WATER PERMIT NO. 6639-3

CENTERVILLE DAM DAM RECONSTRUCTION

TO: Jeff Peters, PE, Division of Administration, SD Game Fish & Parks
FROM: Len Neugebauer, PE/LS *Len Neugebauer*
DATE: September 15, 2005
RE: Hydraulic Review and Comments on Preliminary Plans (DGR#648181, Centerville Dam)

BERM SECTIONS

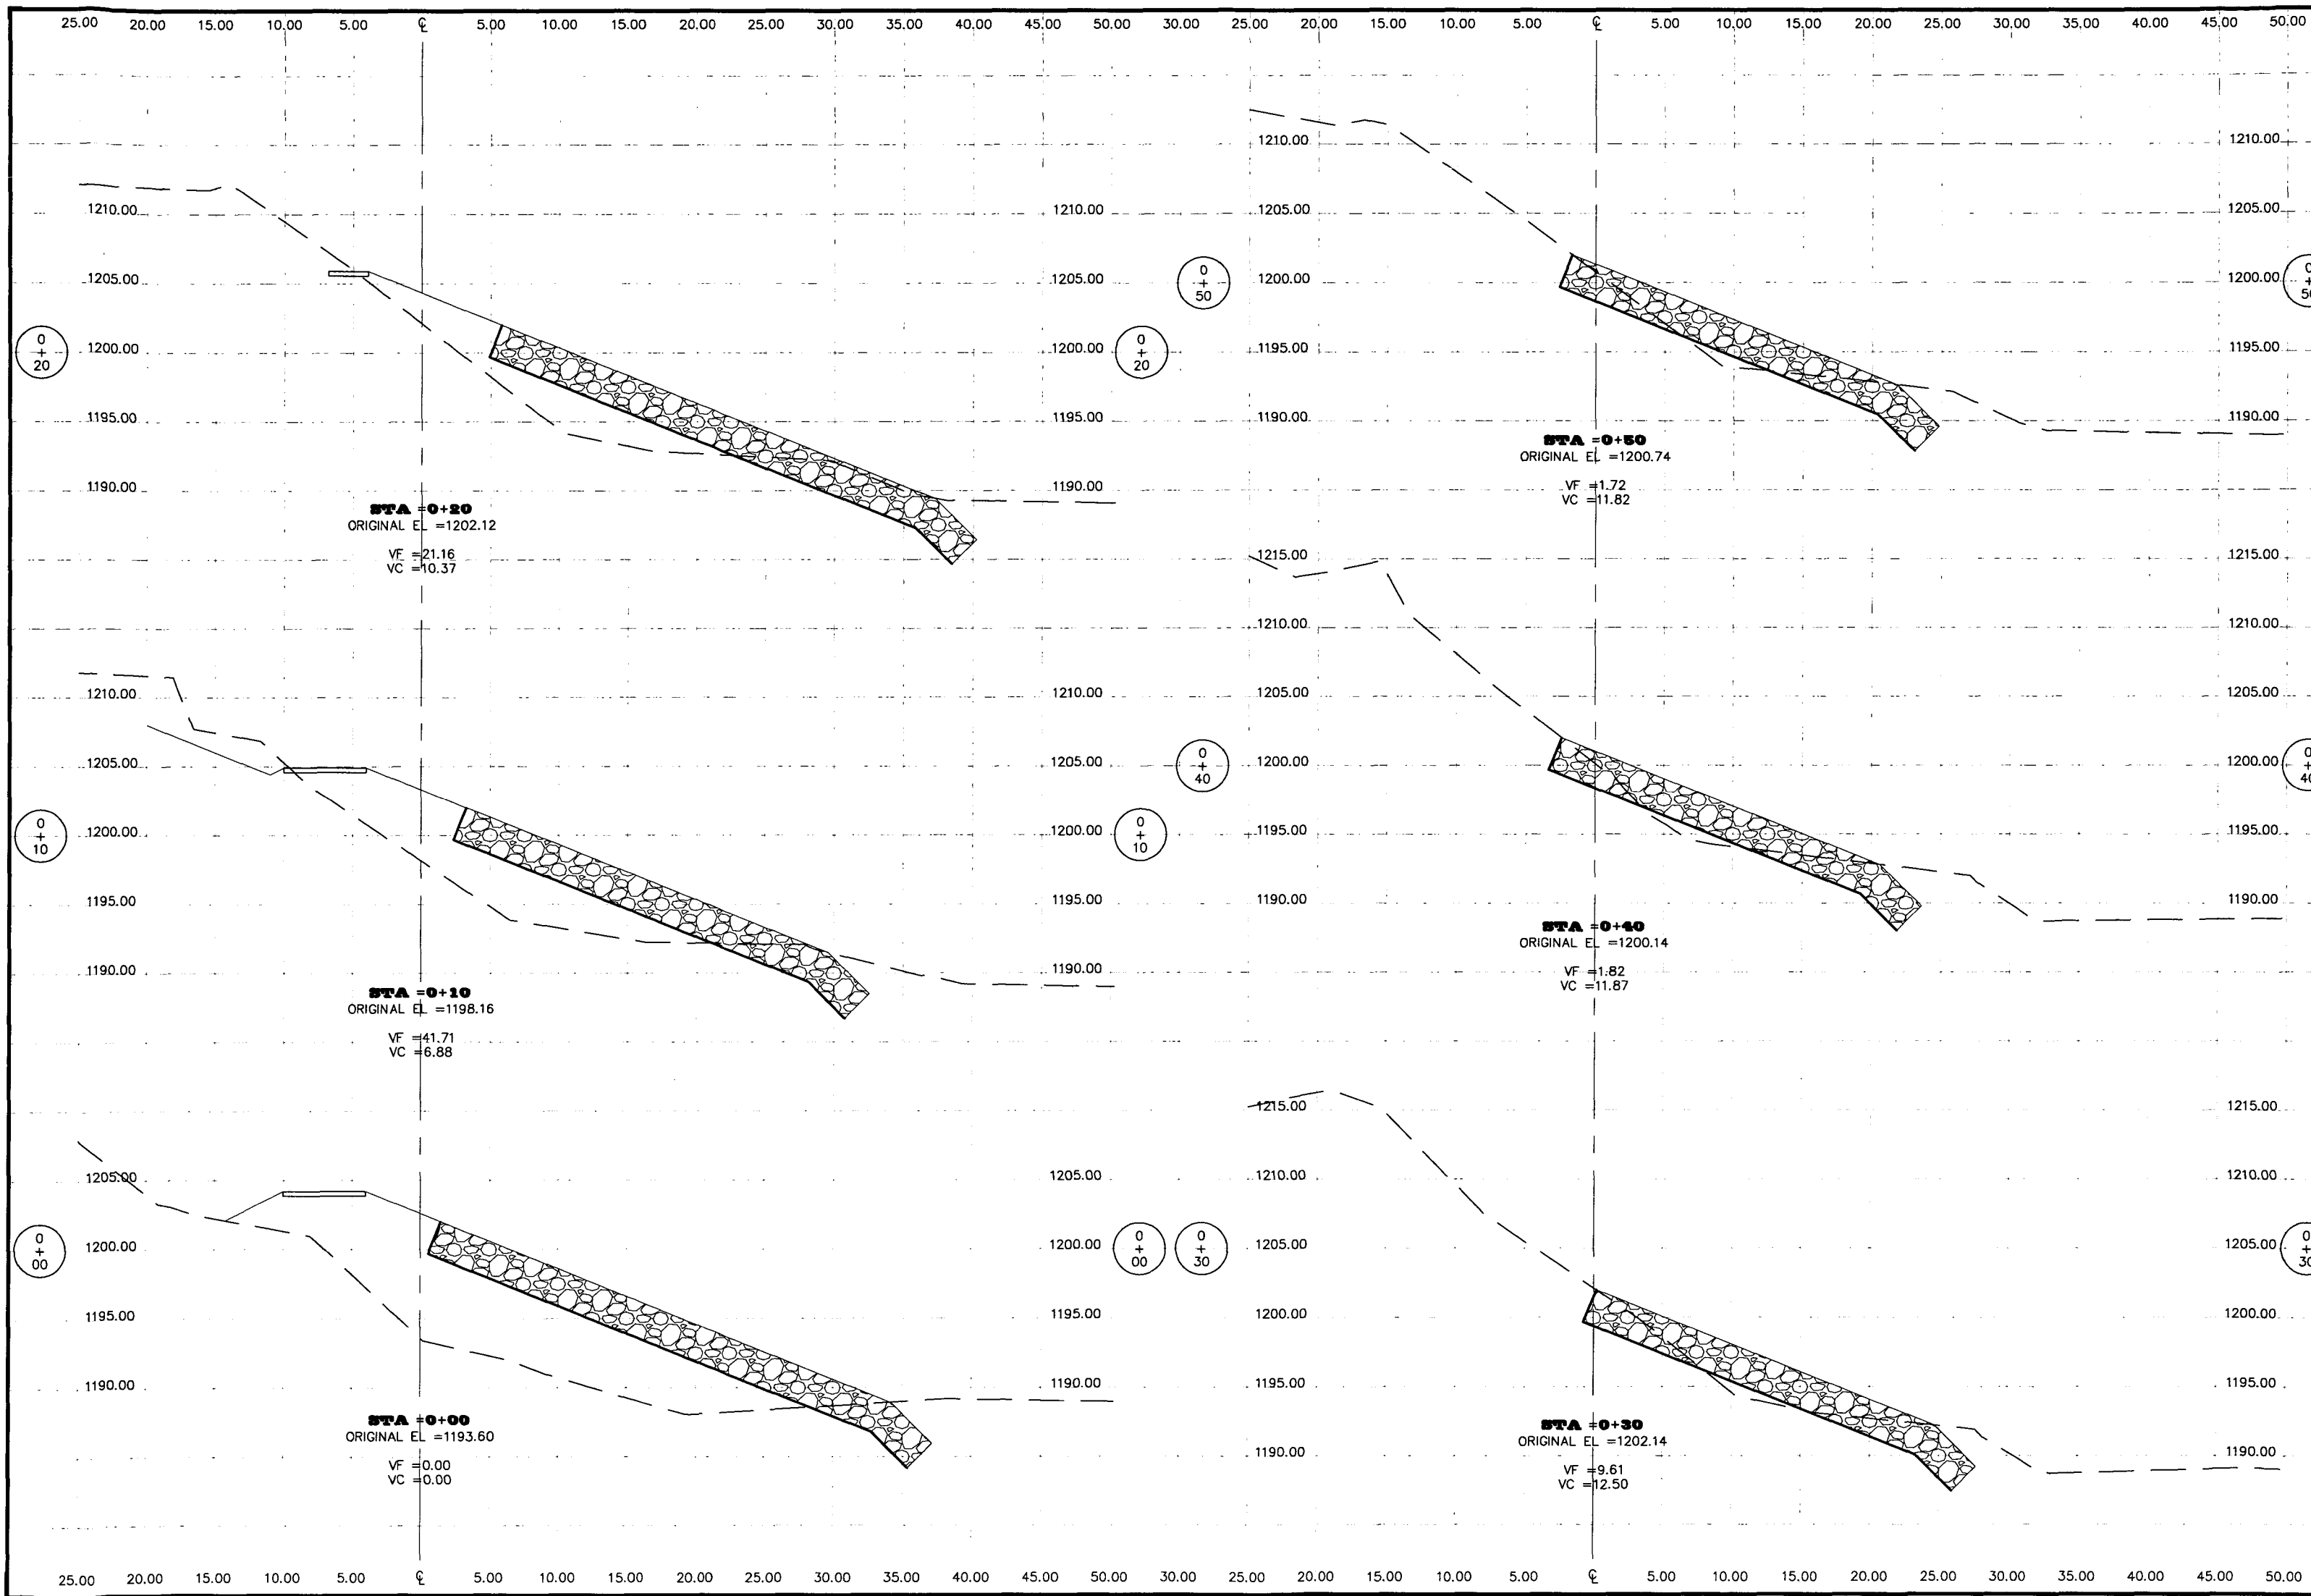
1. Sheet 24 of 47: I would recommend that the top of wall and top of berm at the north end of the spillway extension be at elevation 1207 (3' higher than you show it). I would recommend a clay cut-off core trench and extending your anti-seep wall as shown.

1 SPILLWAY DETAILS
28 SCALE 1" = 12'

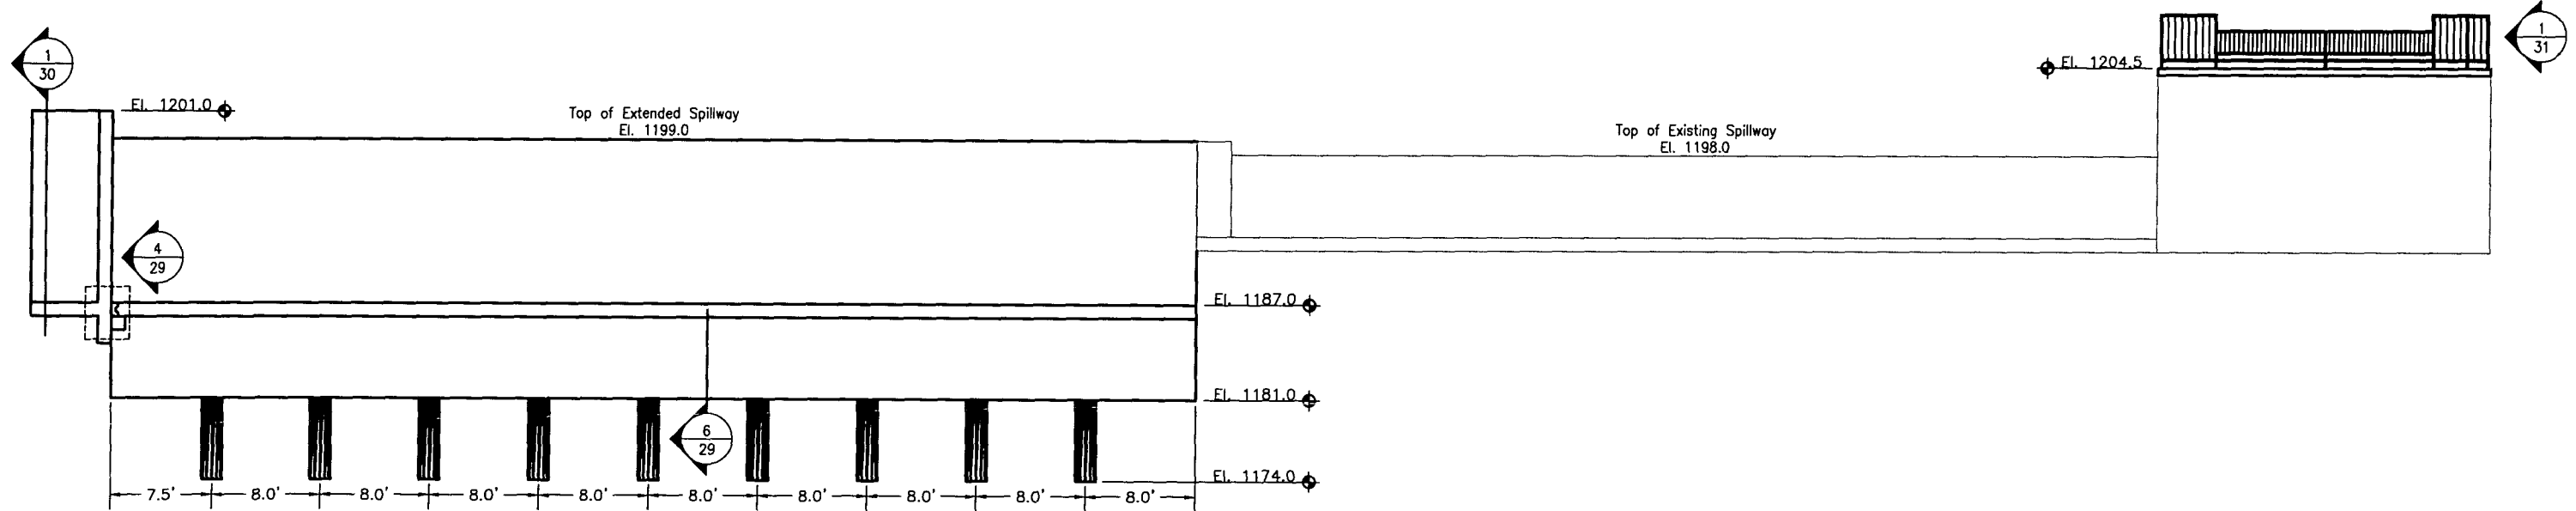
3. Sheet 28 of 47: As I mentioned at our 9/13/05 meeting, I would recommend that the bottom of your concrete cutoff wall penetrate into underlying impervious clay stratum or should extend into a constructed clay core trench which penetrates into the underlying impervious clay stratum, to prevent an underseepage failure.
